## Special Inspection Daily Report

US Army Corps of Engineers	<b>Request for Information Report (RFI)</b>		RFI NO. RFI-0109	PAGE NO. Page 1 of 1
	CONTRACT NO. W911KB24C0025 NA J4001808	CONTRACT TITLE EIE430, Fire Suppression Corrosion Ctrl		PRIME CONTRACTOR ALCAN BUILDERS INC.

REQUESTED BY Craig Sandine	DATE REQUESTED June 28, 2025	POTENTIAL COST IMPACT No	POTENTIAL SCHEDULE IMPACT No
RFI SUBJECT	Braced Frame Footing-Pedestal Clarification		
SPECIFICATION SECTIONS	03 30 00		
DRAWINGS	S-101 & S-503		
SUBCONTRACTOR

**A1 BRACED FRAME FOOTING**  
1" = 1'-0"

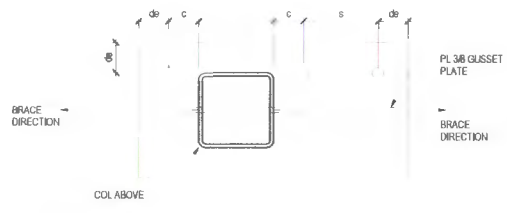
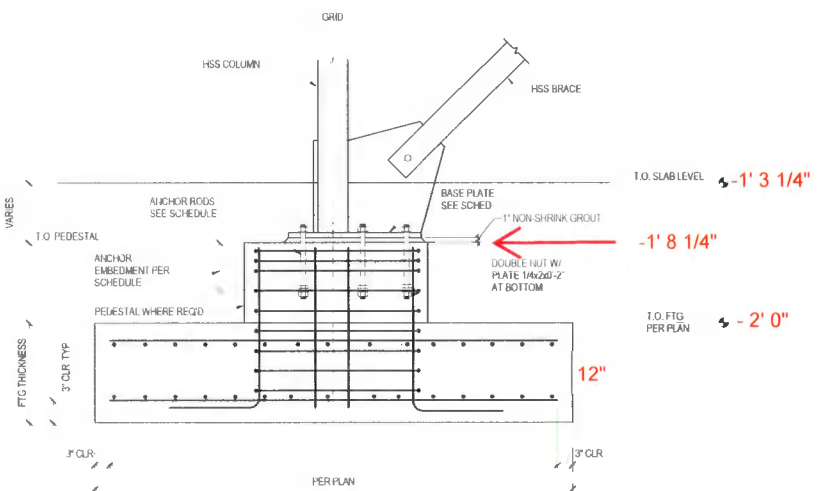
Drawing S-101 show tops of footers at Grid Lines 1.6 and D.8 are shown to be -2.0' to match existing strip footers. With the finished floor of the Fire Pump Room being -1' 3 1/4", Detail A1 on S-503 doesn't accurately represent the conditions at the Fire Pump Room footers. Given elevations, the pedestal would be 3 3/4" tall. The anchor bolts are 9" long, so following Det A1, the bolts would transition a cold joint at the short pedestal.

We recommend increasing the thickness of the footer to 15 3/4" thick so the anchor bolts are fully set in a single pour. This would apply to 4 column locations.

Thicken the footer at 4 column locations depicted in attached.

The proposed thickening of the footing in the indicated locations is acceptable.
